**From:** Warrior, Andrew  
**Sent:** 20 February 2020 14:13  
**To:** Kelsey Blain  
**Subject:** RE: Listed Building Consent and Planning Application for Mount Misery Farm, Hackness

Project  
Mount Misery Farm

Content  
Casement Window Details and Sections

Content  
Yorkshire Light Window Details and Sections

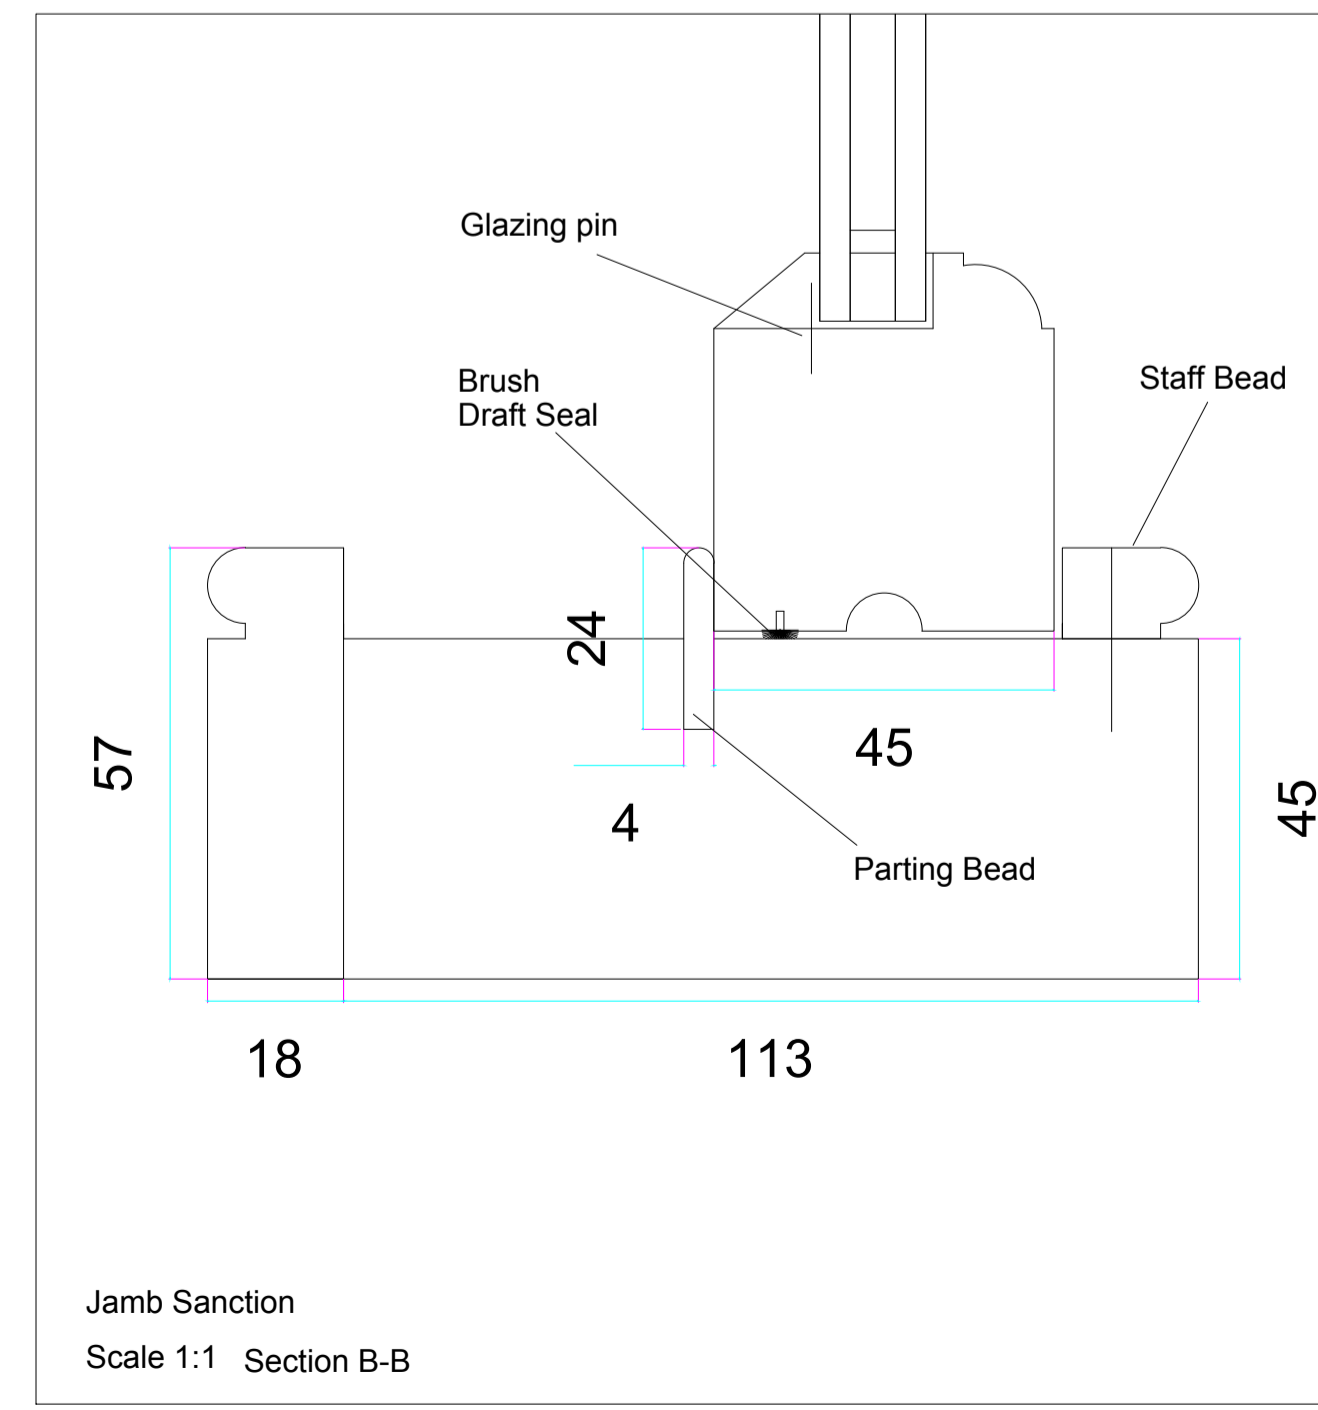
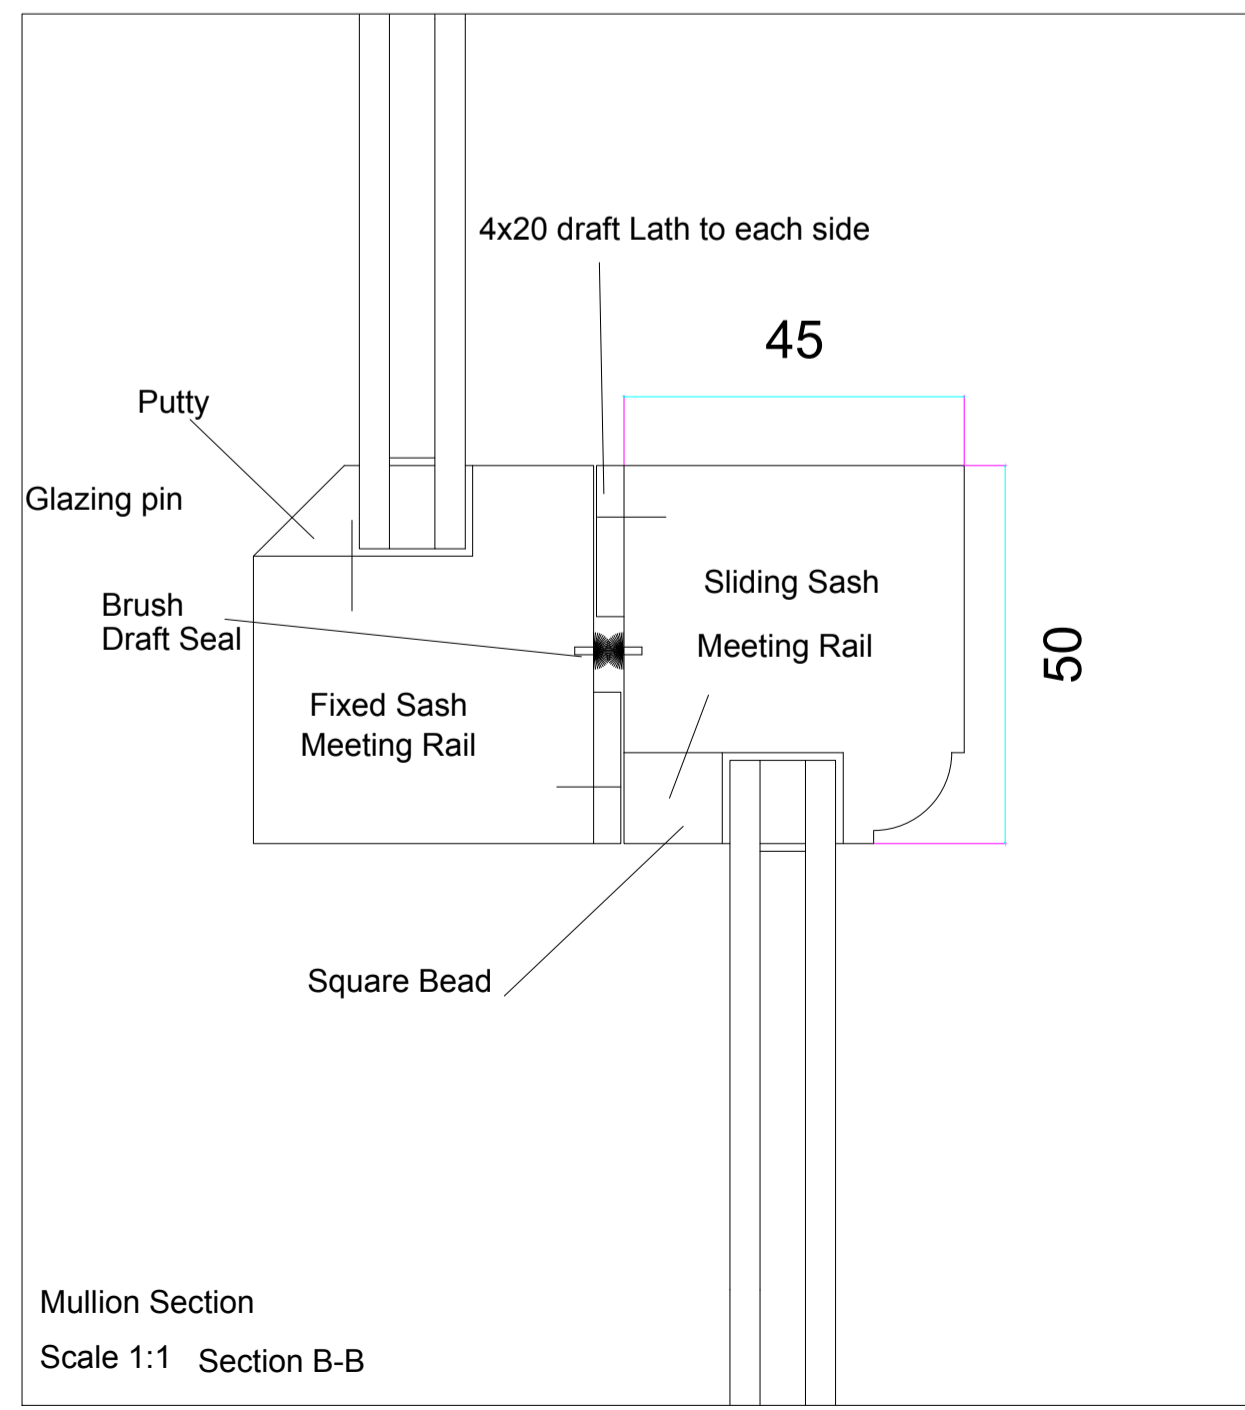
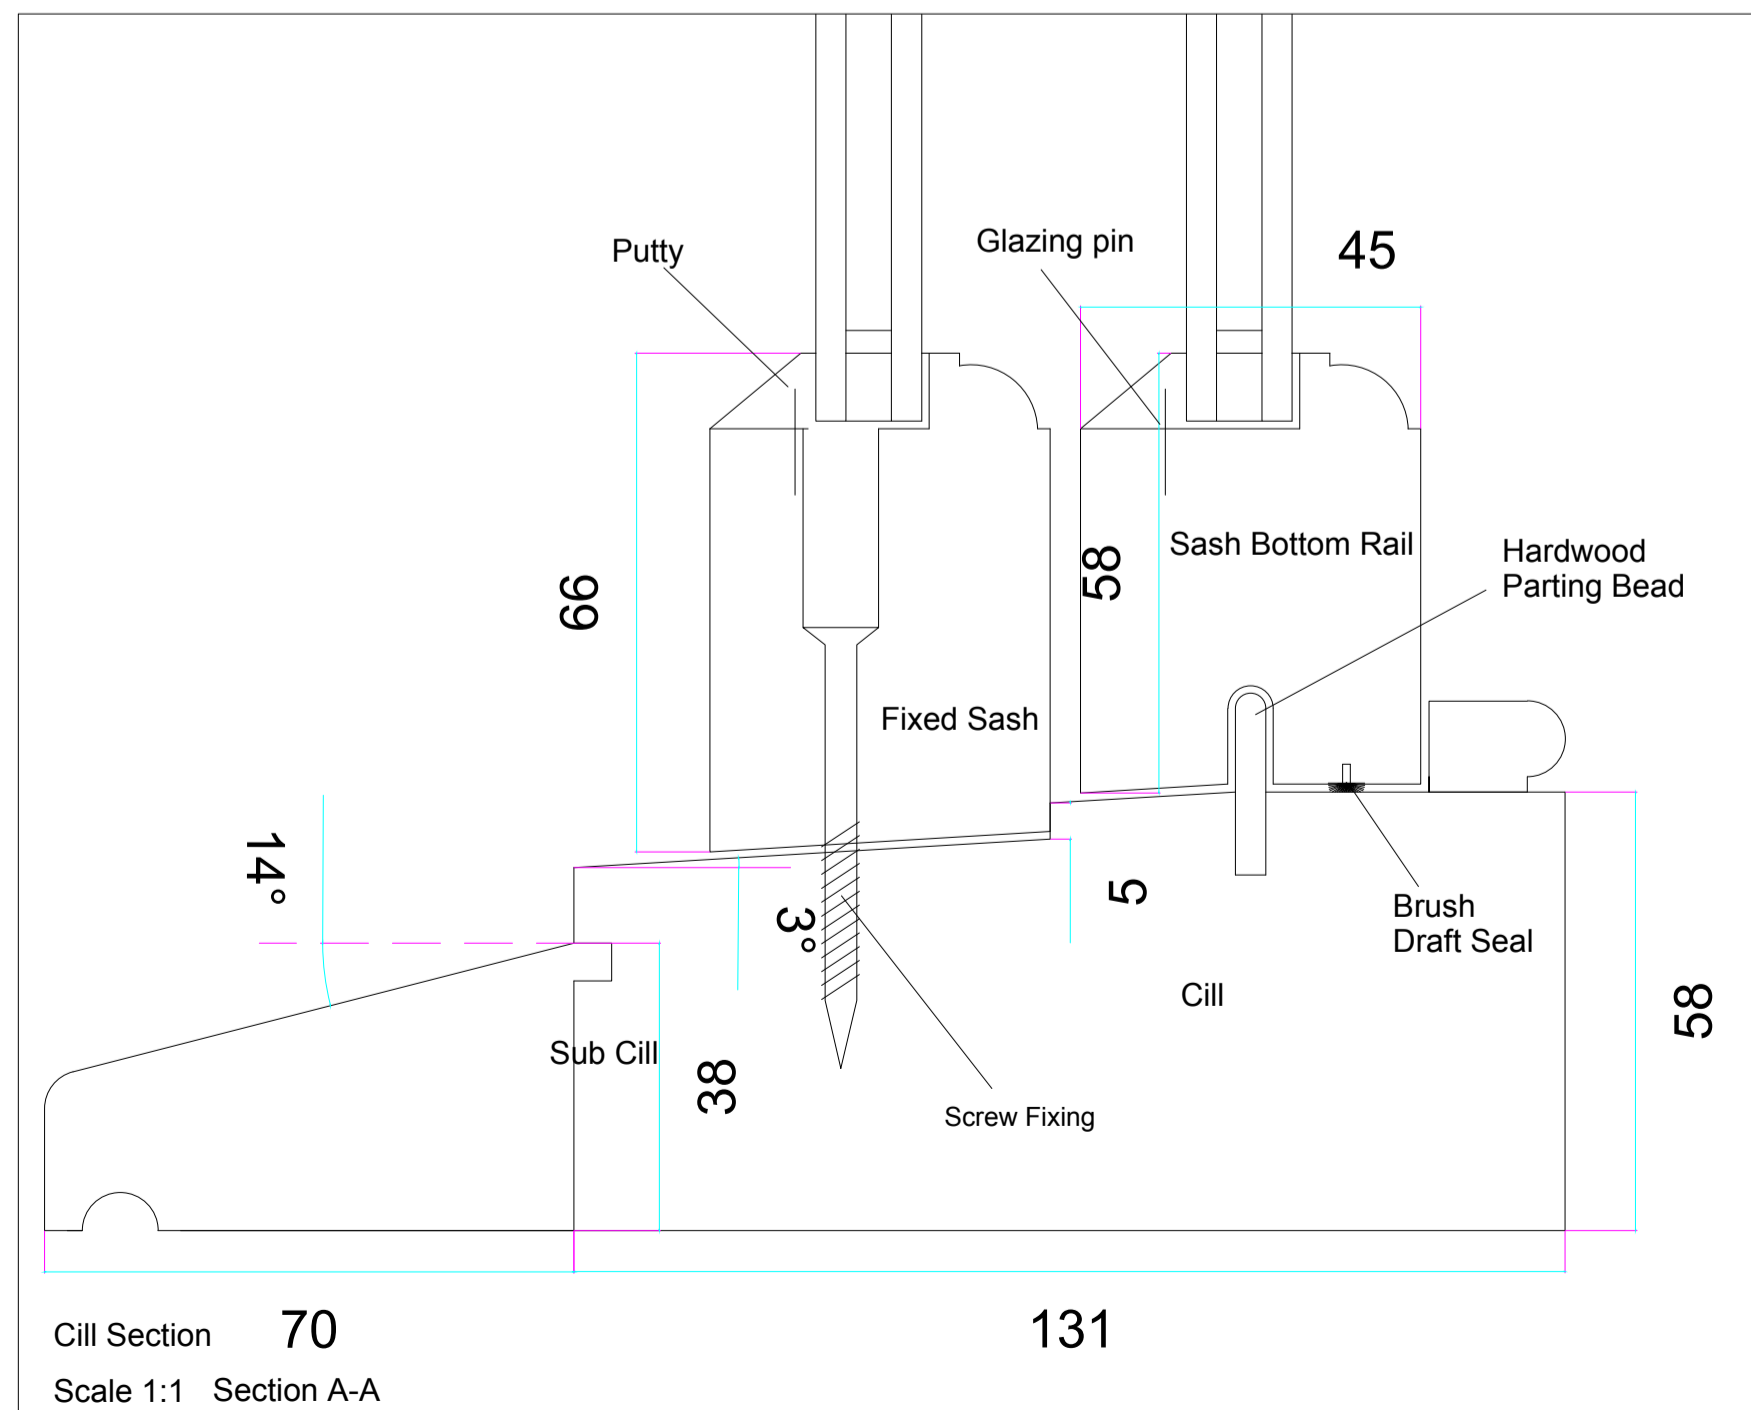
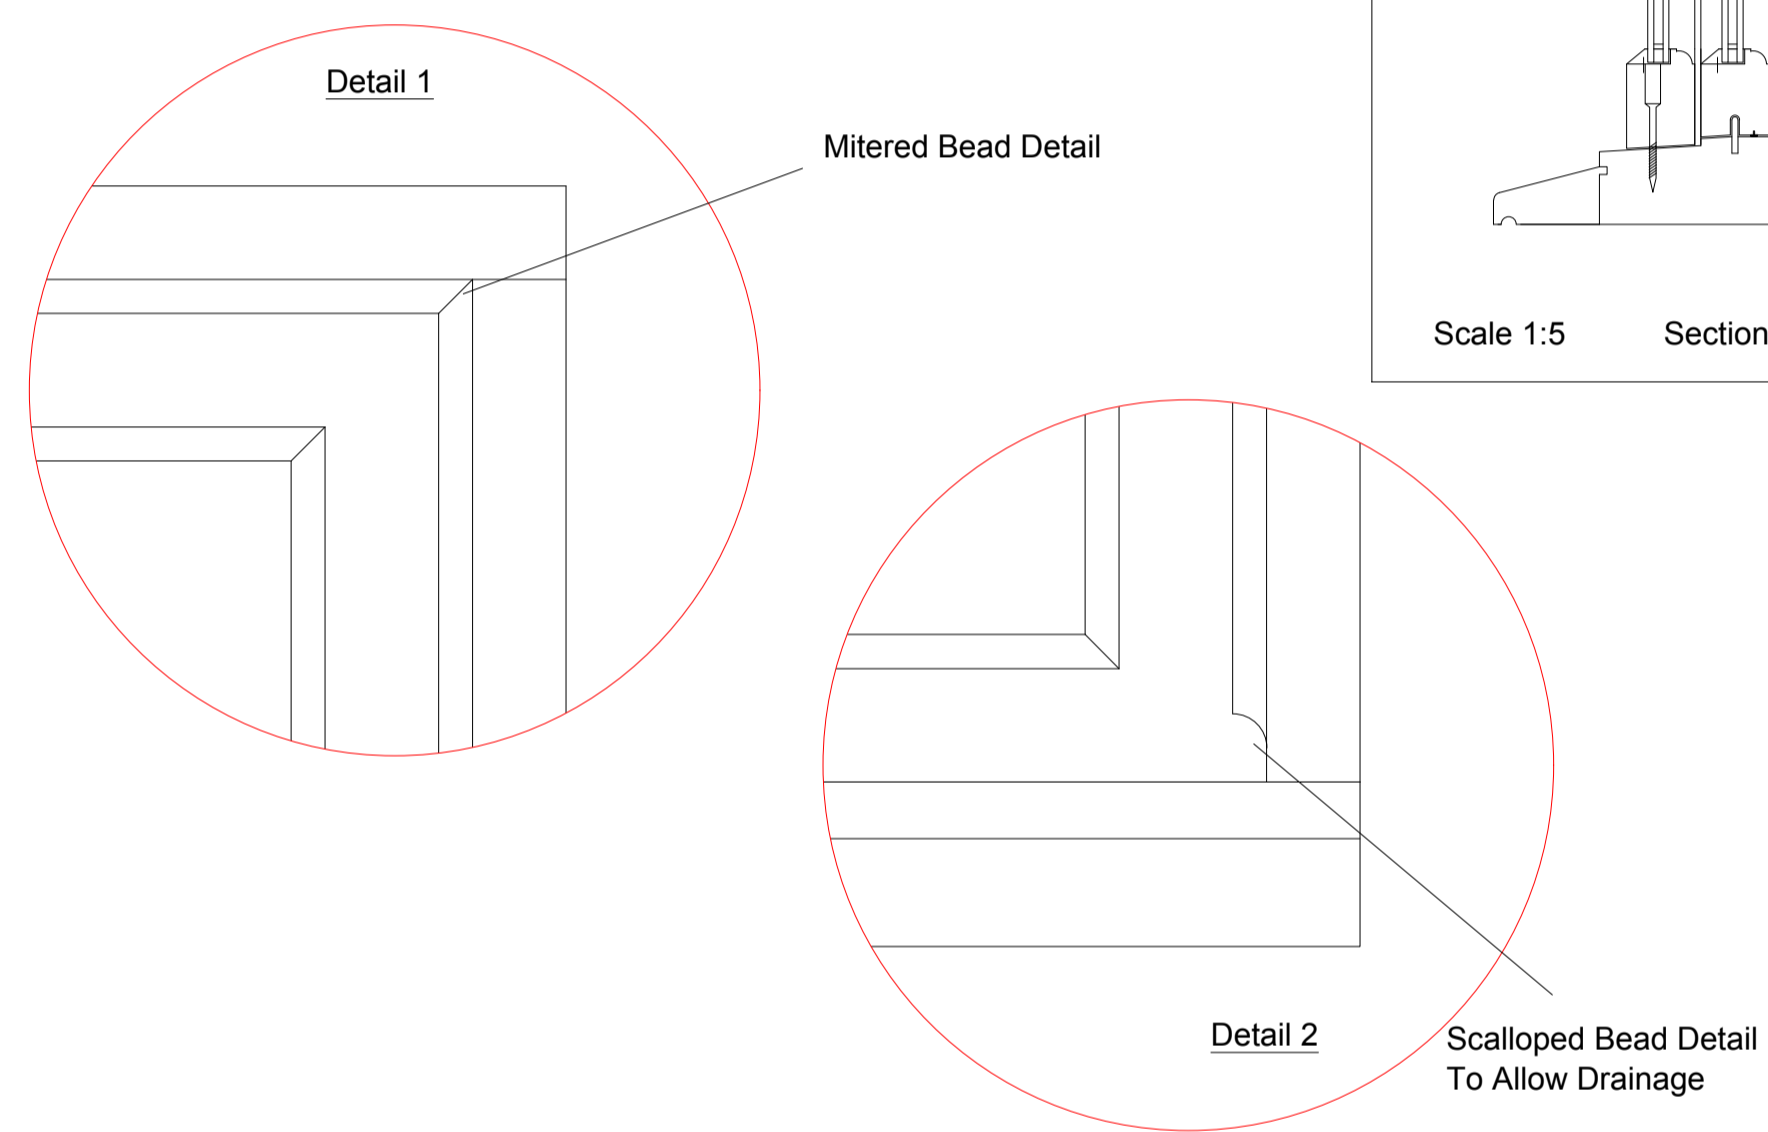
Yorkshire s/s

- Glazing to be putty pointed, not beads as mentioned above.

- Reduction in size of glazing bar, 22mm if possible?

- Could consideration be given to use of a leaded cill, rather than a projecting cill – see example attached

Although timber beading would be more suitable for double glazed units and the profile would look like putty as the timber beading in the photo you provided I would be able to specify putty

As we are fitting double glazed units it would not be possible to reduce the size of the glazing bars. The double glazed unit spacing bar has a depth of 10mm, the rebate and the glass should have a 2mm clearance this is why the rebate depth has to be 12mm. When fitting beads to hold the unit in place the feather has to be sufficient to provide a secure fixing for the pins as you have requested putty the thickness of the feather is crucial to provide a safe and secure fixings.

The projecting cill is preferred as it will allow water to drain away from the building and prevent the water from traveling back in to the building by capillary action.

The sliding sash to the Yorkshire light will be secured by a fitch fastener.
